**Río Puerto Nuevo Flood Control Project
San Juan, Puerto Rico**

APPENDIX G: PERTINENT CORRESPONDENCE

May 29, 2023

**RÍO PUERTO NUEVO FLOOD CONTROL PROJECT PUERTO RICO
CONTINUING CONSTRUCTION VALIDATION REPORT:
SUMMARY AND EVALUATION**

Figure 1. Annual federal funding rate for the río Piedras river flood control project. Data are from Kelly (2020).

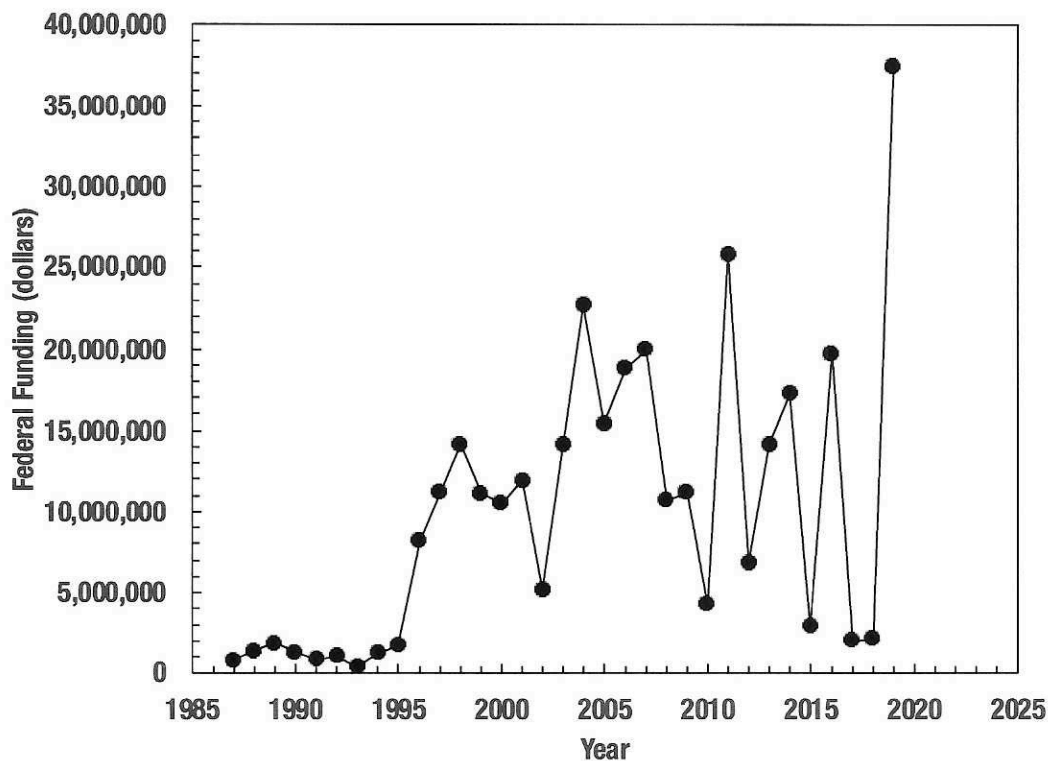
Section 1.6. Total sunk cost is equivalent to obligated funds and was \$420 million as of October 2019. Included in those costs are preconstruction, engineering and design (PED), construction, LERRD's, and other associated costs. Figure 1 of this summary contains the history of federal funding for the channelization project since it was authorized.
